ENVIRONMENTAL SURVEY

CAPCO - Ragland Plant

AMERICAN SMELTING AND REFINING COMPANY
Department of Environmental Sciences
Salt Lake City, Utah

Report Date: January 20, 1975

SMALL COUPLING LATHE

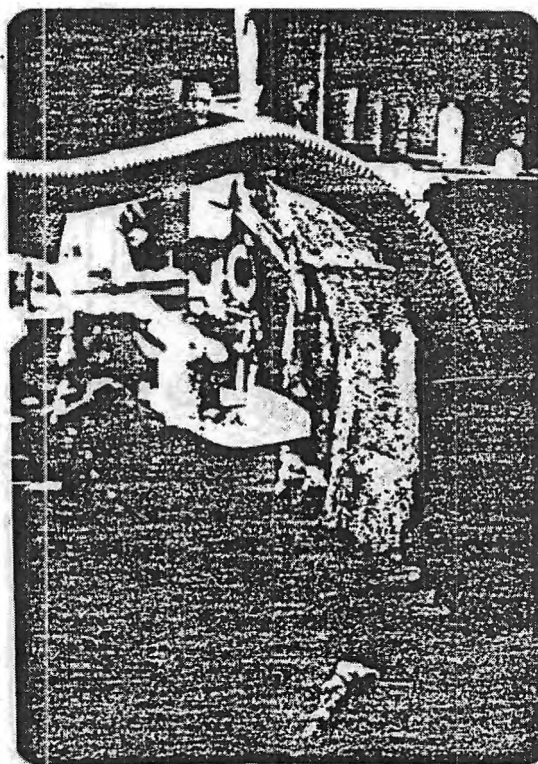
Dry couplings are being cut, and ventilation system is not picking up all of the dust produced. Floor around operator is covered with asbestos waste.

SMALL COUPLING LATHE

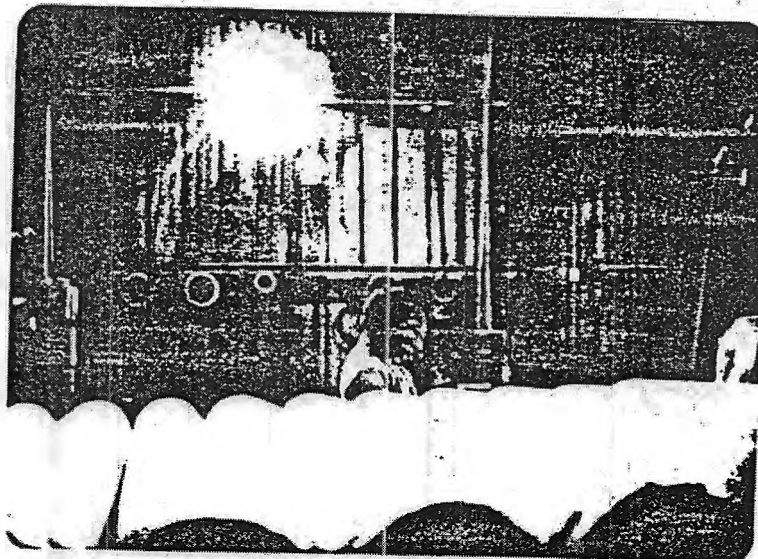
Better housekeeping to prevent accumulations of asbestos waste, as shown on the machine and floor, is needed.

FLEXTESTER

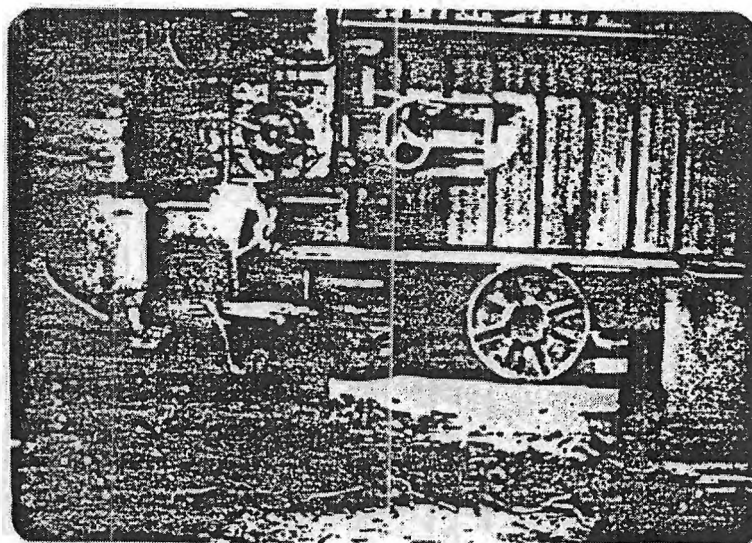
The employee is using a hand-grinder which is not ventilated.

SHOP AREA

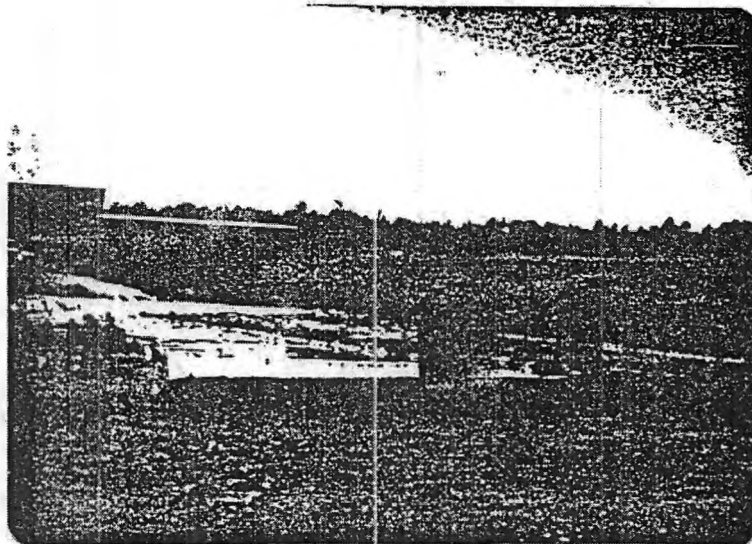
Housekeeping around the shops should be improved.

SOLID WASTE DUMP

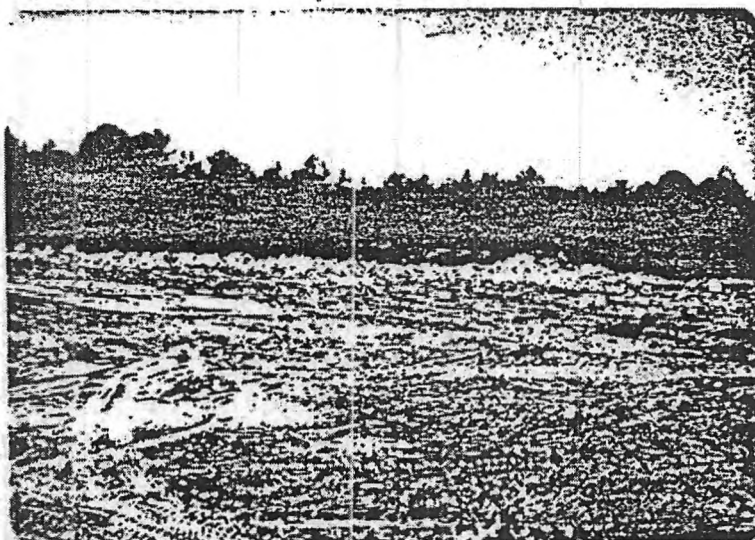
Pile of loose asbestos waste
is near center of picture.

The dump should be converted
to a sanitary landfill. A
State permit may be needed.
